## Change Notice

Rev.1: 2024-12-20 Nägler  
1 of 1

# HTPA16x16dR3

## HTPA16x16dR3 Change Notification

### Change in Pixel Orientation

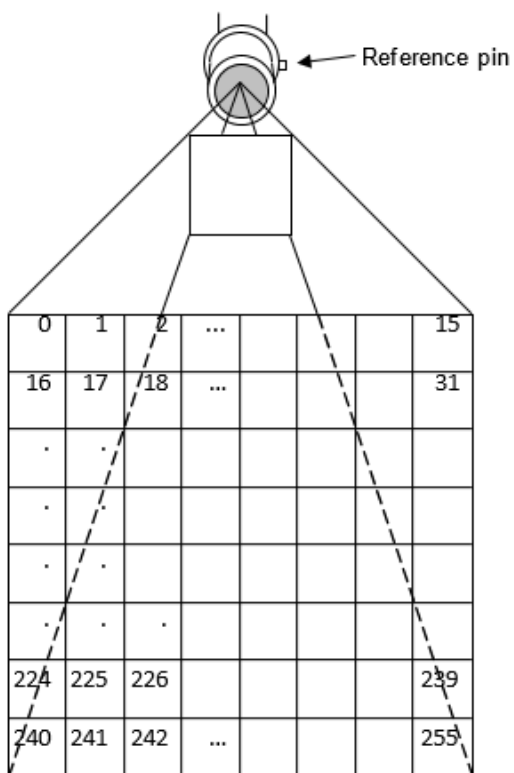
1. Pixel orientation is mirrored on the vertical axis as shown under **Change in Pixel Orientation** below.
2. Two *Ambient Temperature Compensation Pixels*, called ATC1 and ATC2 were added. This changes the data read-out order. Please refer to the 16x16dR3 datasheet for more details.

16x16d Rev. 2

new 16x16d Rev. 3
